## Contract Quantity Adjustment/Change Order

Project Name: 13001.01 University Blvd Widening Date: 6/17/21

City Project ID Number: 13001.01 Change Order/Quantity Adjustment No. 3

Change Order Proposal Number: 8 REV 2

FROM UNIVERSITY OAKS BLVD TO SUBMIT NO  
UNIVERSITY BLVD  
SWAP PLAN

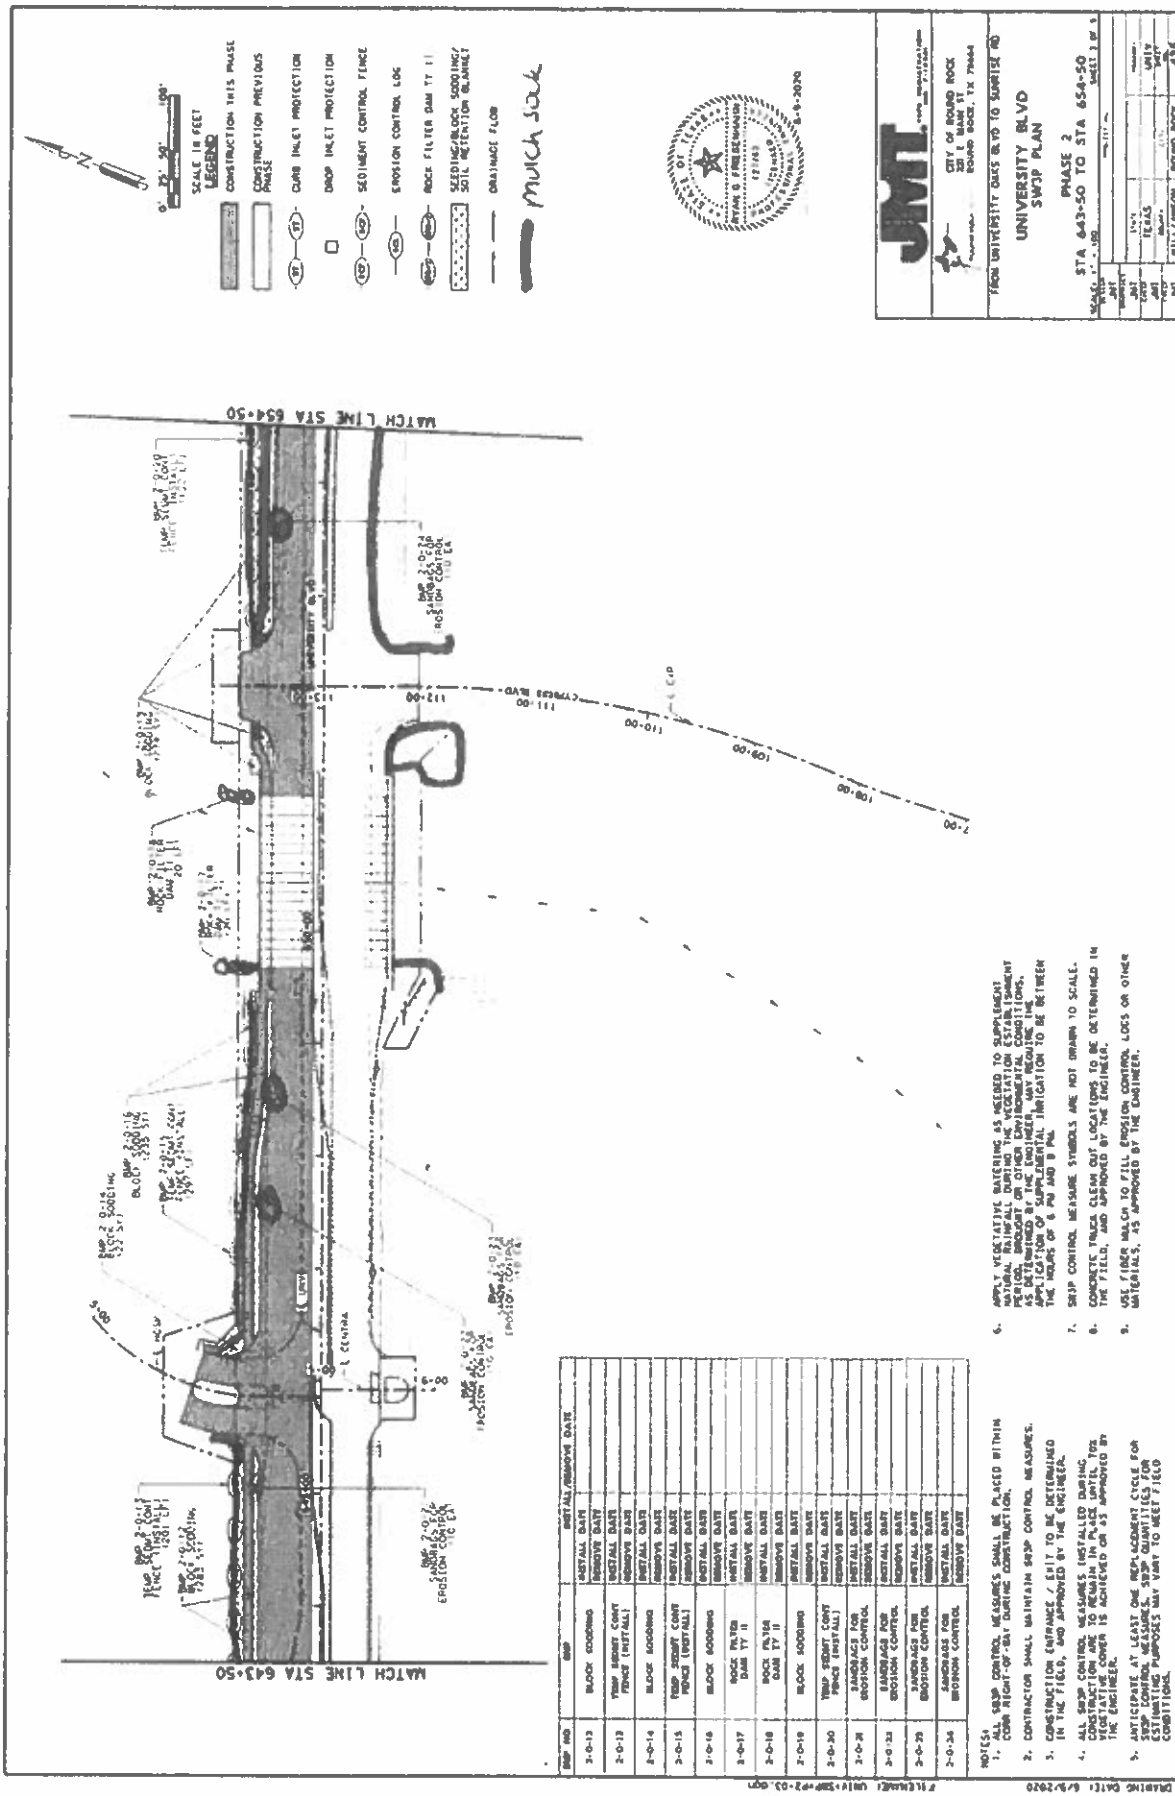
**PER COP #8 (Attached) 1. (Attached SWPPP Map) Additional erosion control measures requested to be added by TDPES agent. 2. REALLOCATION of conduit quantites for bore quantities to be billed under 3" PVC SCH 80 trench. 3. Quantity overrun of trench safety systems.**

1. Added erosion control measures per SWPPP representative recommendation (SWPPP map attached). 2. Bore conduit to be paid for under trenched 3" PVC SCH80 3. Quantity overrun of trench safety systems
